Agenda
Village of Arlington Heights
Design Commission
Community Room, 3rd Floor

STAFF DESIGN COMMISSION REPORT RE-REVIEW

Project Name: 13 E. Miner Street
Project Address: 13 E. Miner Street
Prepared By: Steve Hautzinger

DC Number: 15-097
Petitioner Name: Frank Panzarino
Petitioner Address: 904 S. Edgewood Lane
Mt. Prospect, IL 60056
Meeting Date: August 11, 2015
Re-Review Meeting Date: October 27, 2015

FRONT ELEVATION

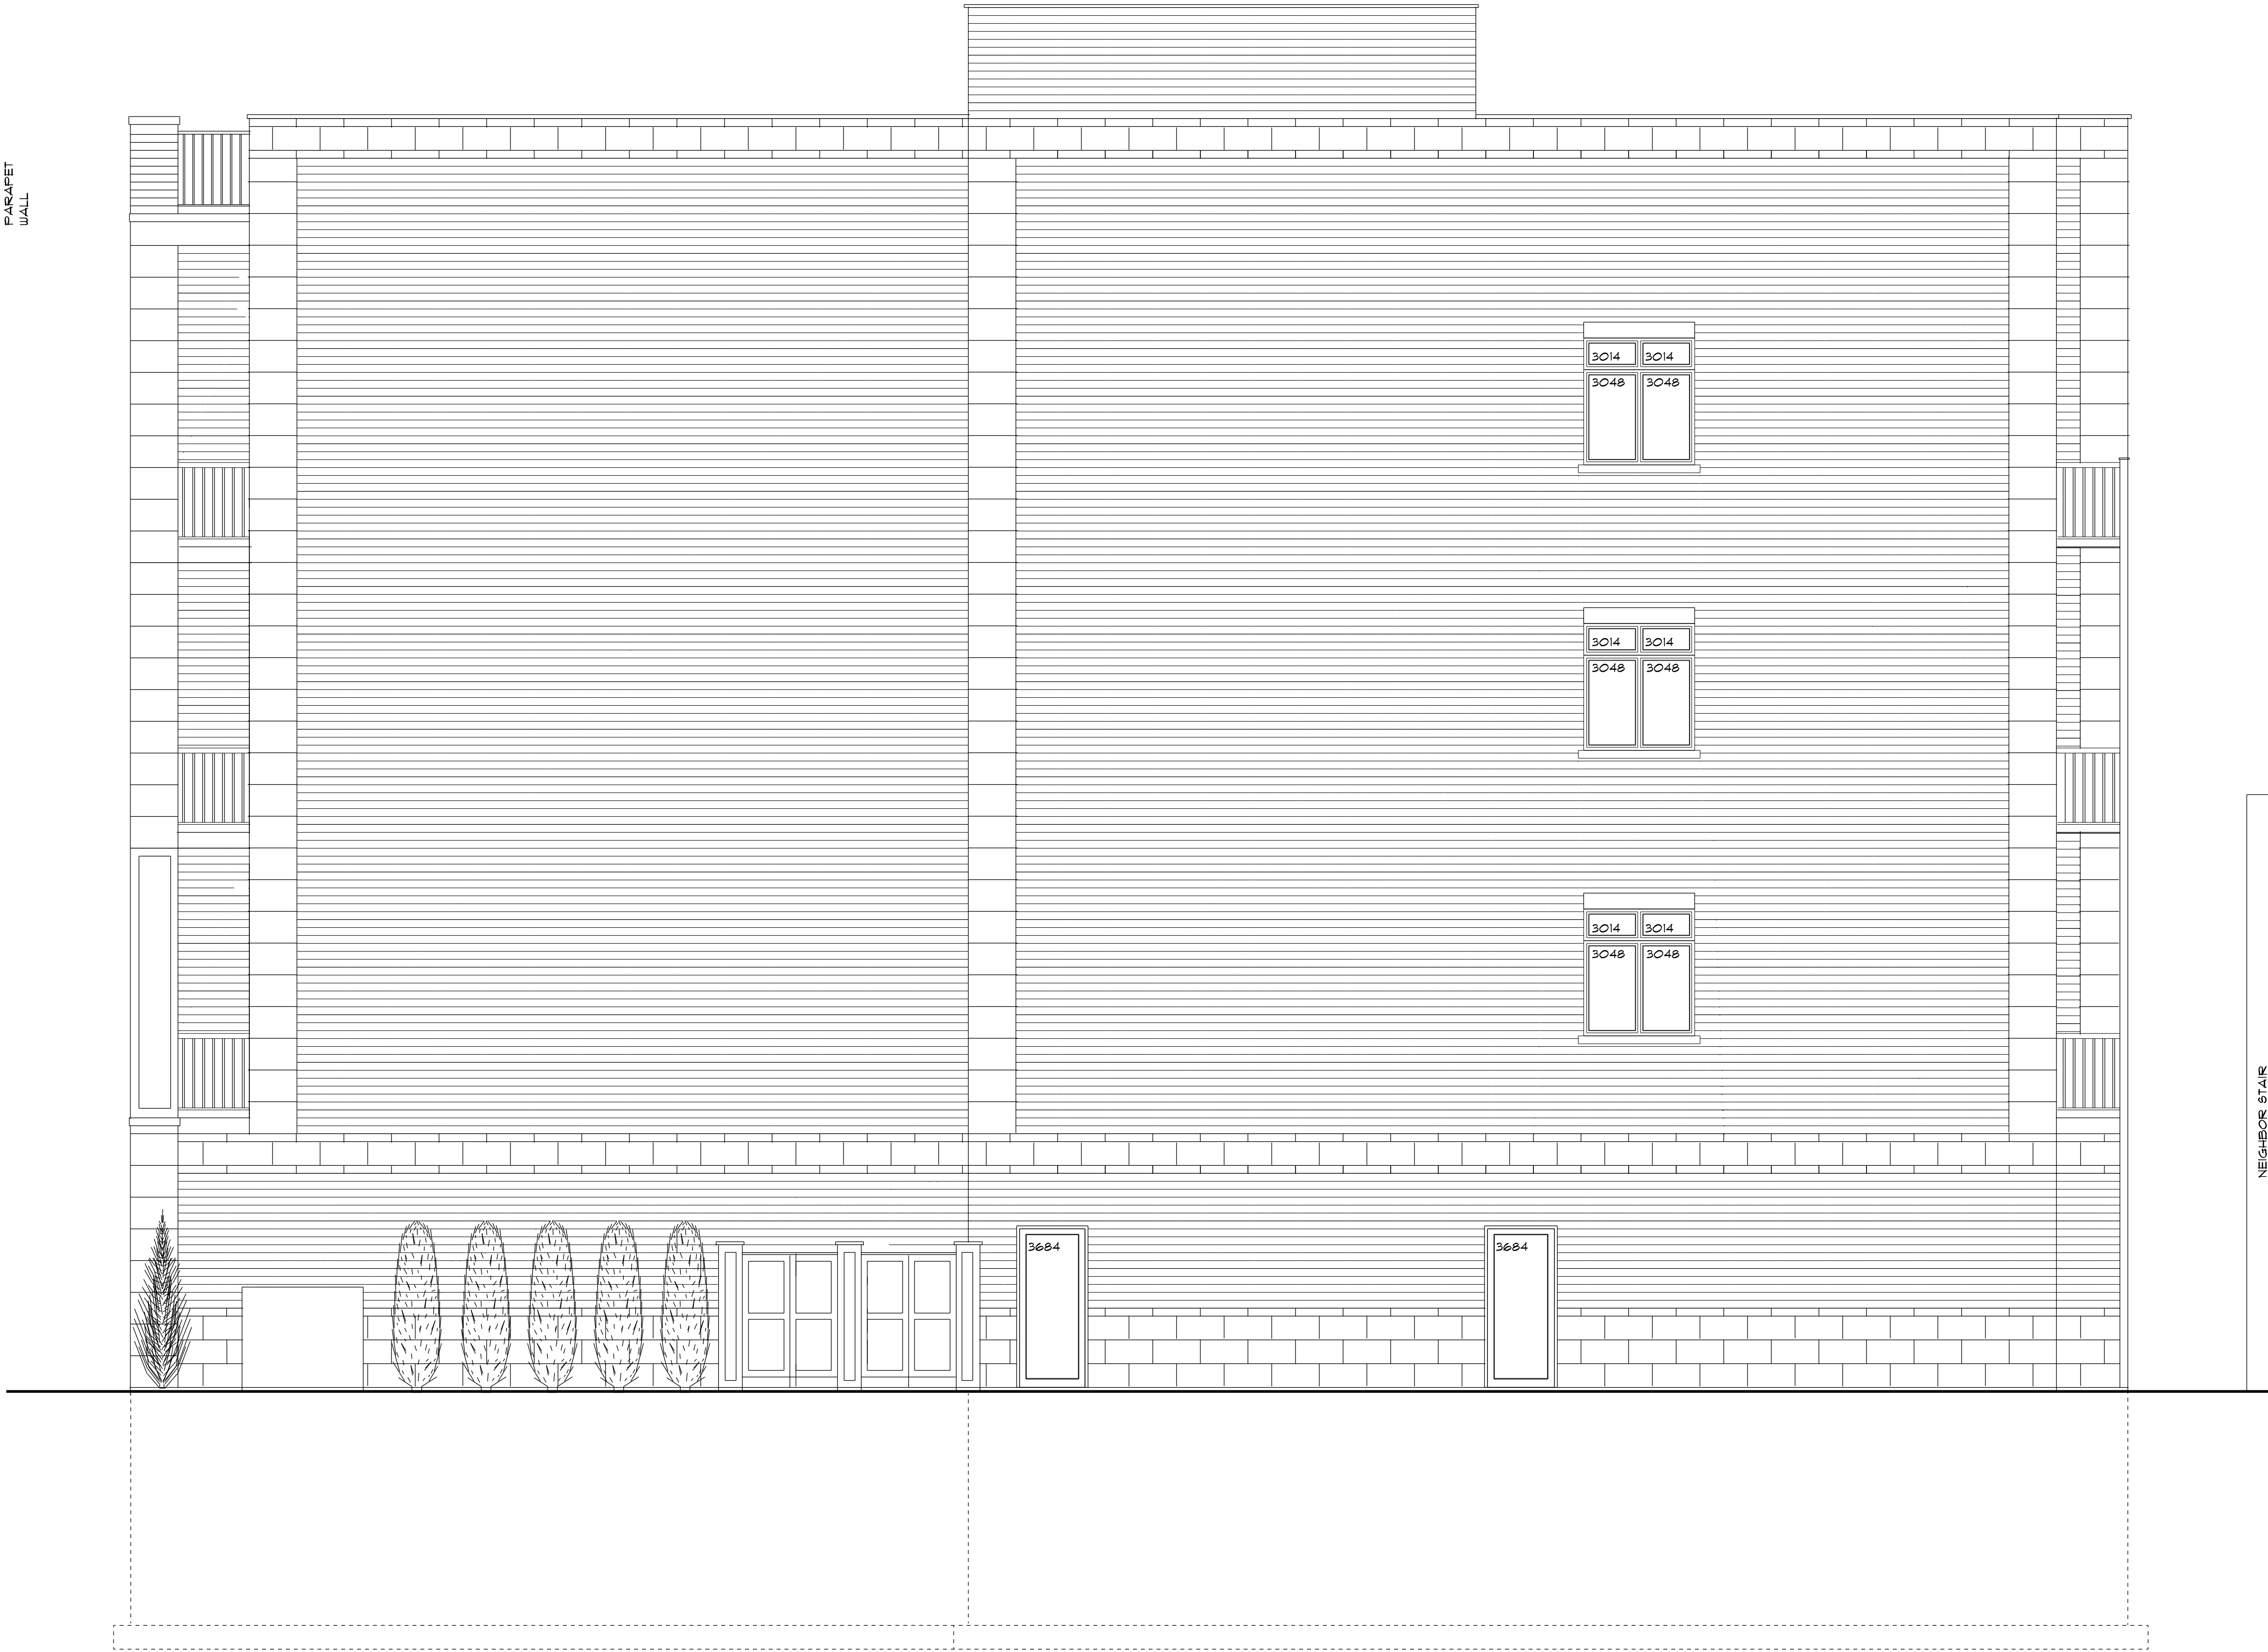
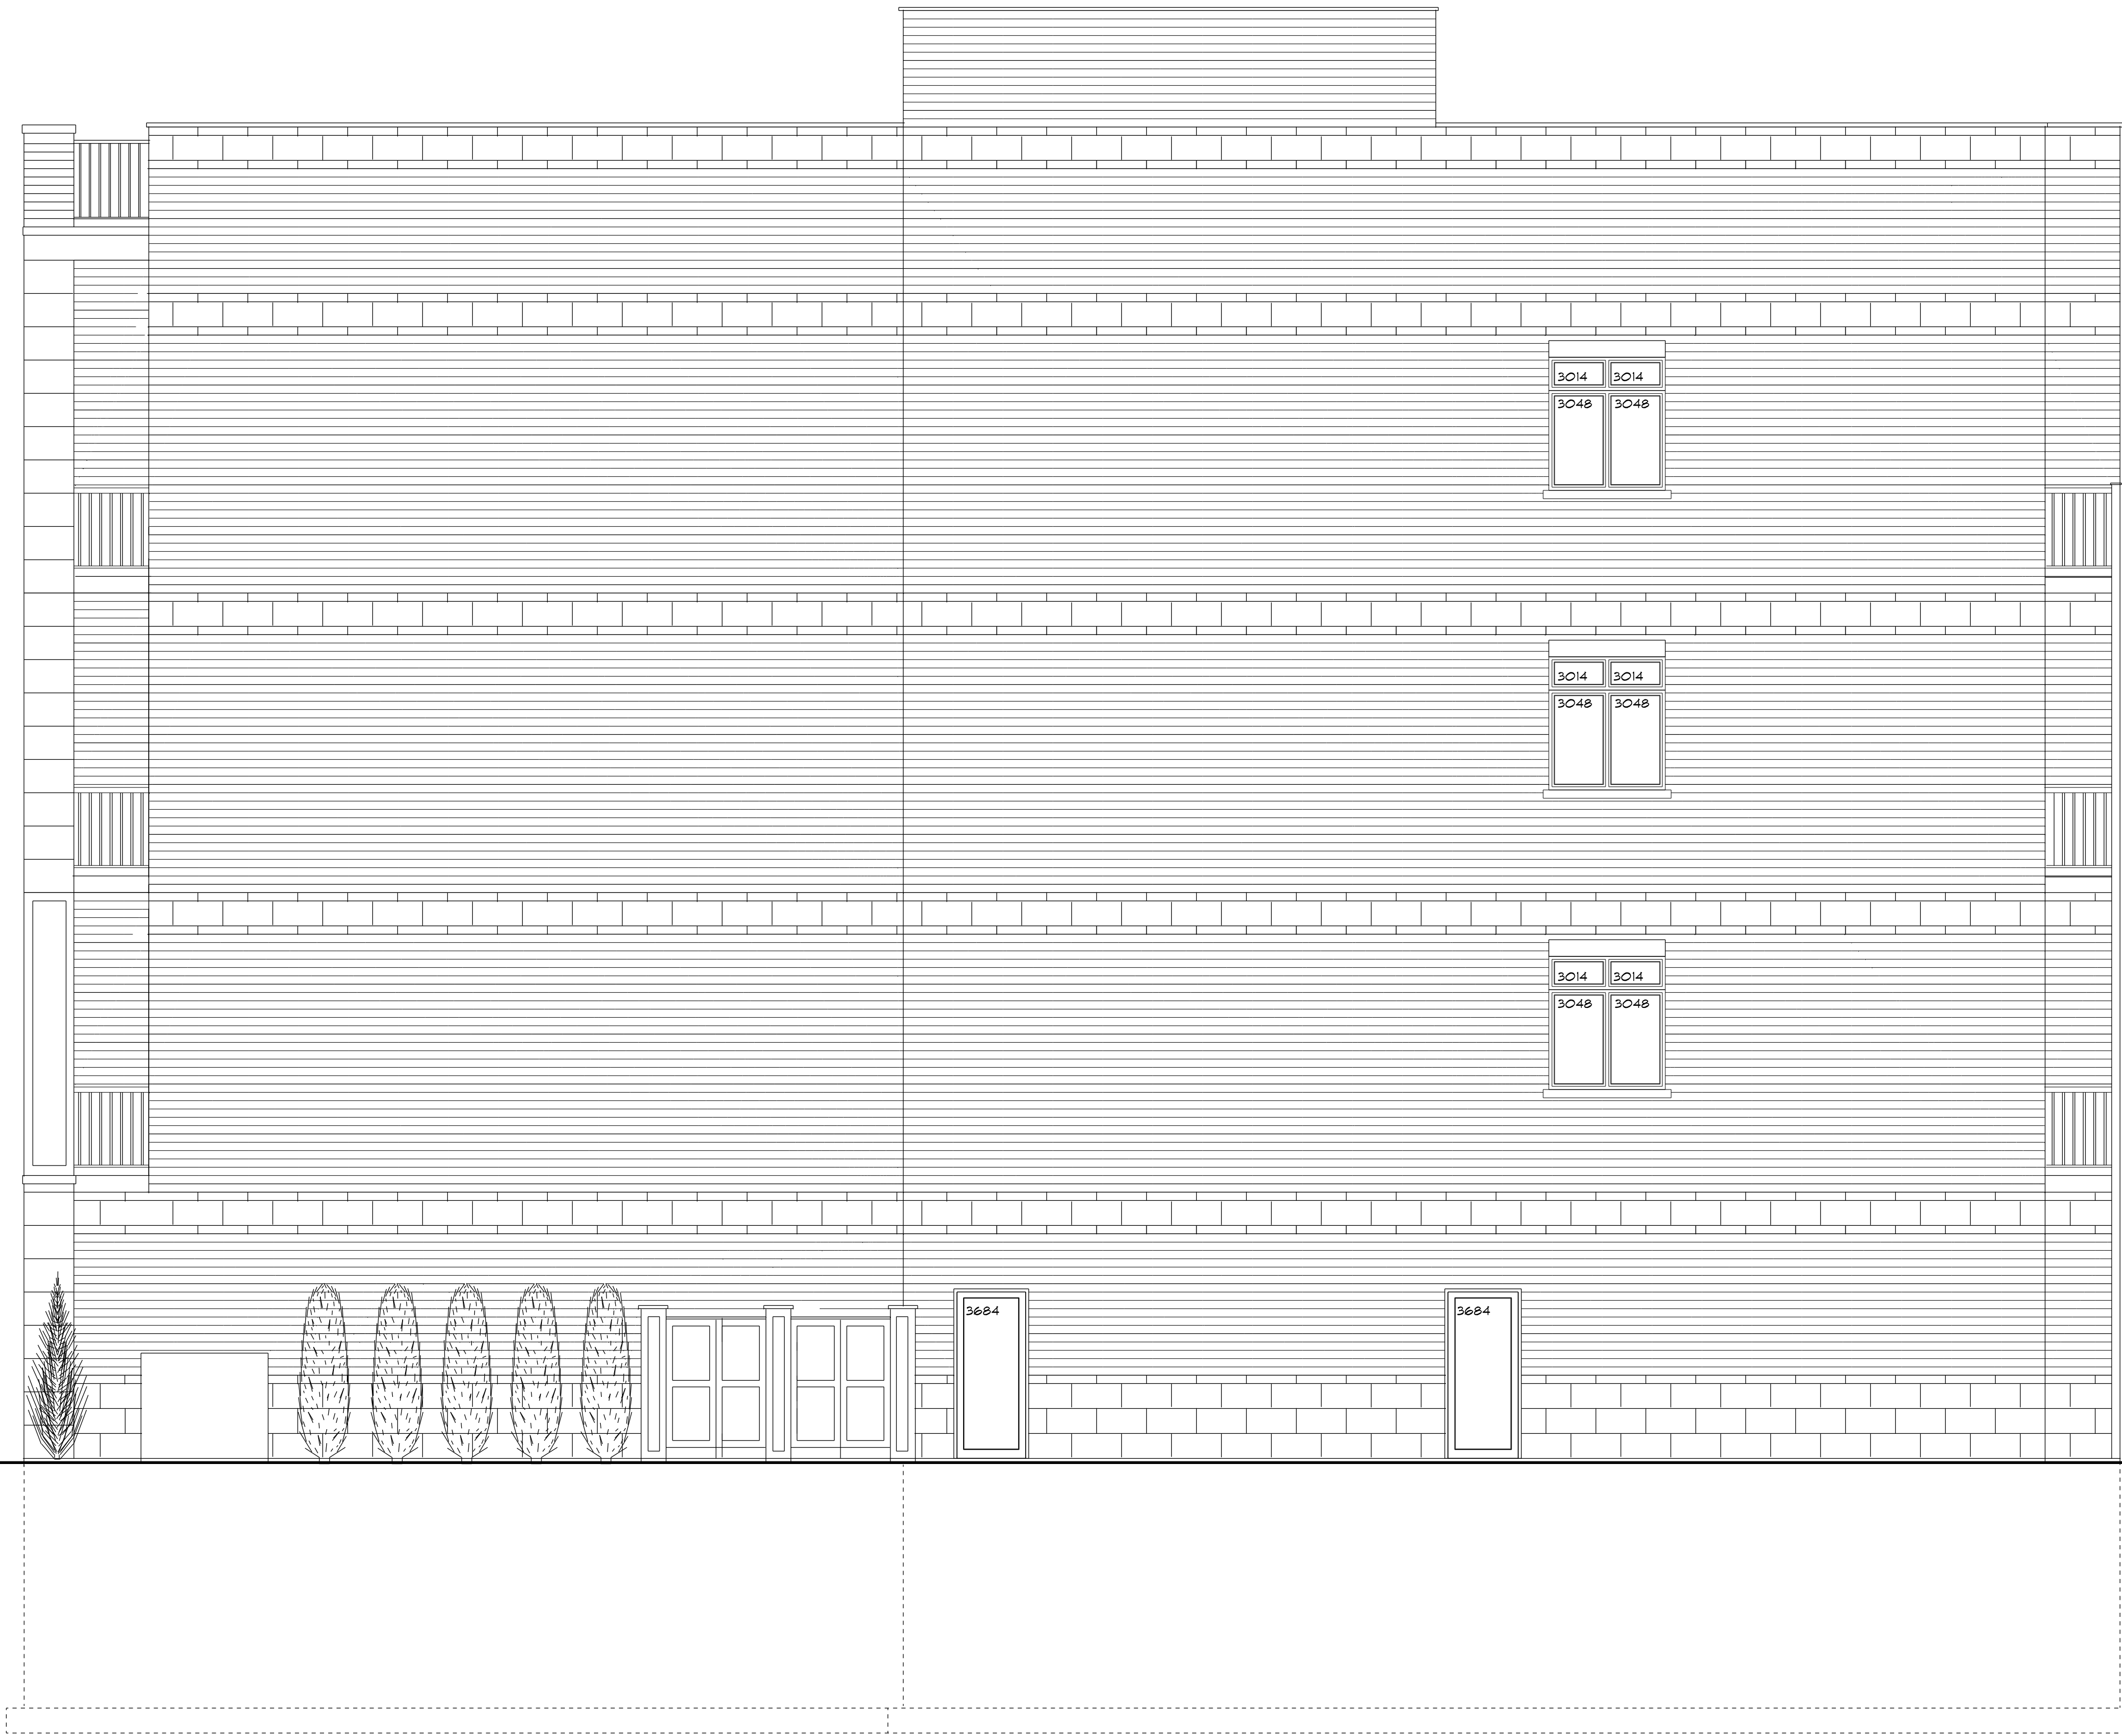
Front (north) Elevation. The revised front elevation is a nice improvement from the original proposal. The revised detailing with straight lintels has a more modern appearance than the previous arches and keystones.

1. The color scheme using just one brick color is preferred.
2. Change the corner brick pier at the roof level to stone to match the stone pier below.
3. The front elevation should include retail storefronts on the first floor to add visual interest at the sidewalk level, and to enliven this area of the Downtown (refer to the Central Business District Design Guidelines requirements below).

3. Change the corner brick pier at the roof level to stone to match the stone pier below
4. The front elevation should include retail storefronts on the first floor to add visual interest at the sidewalk level, and to enliven this area of the Downtown. Storefront design to be approved by Staff.
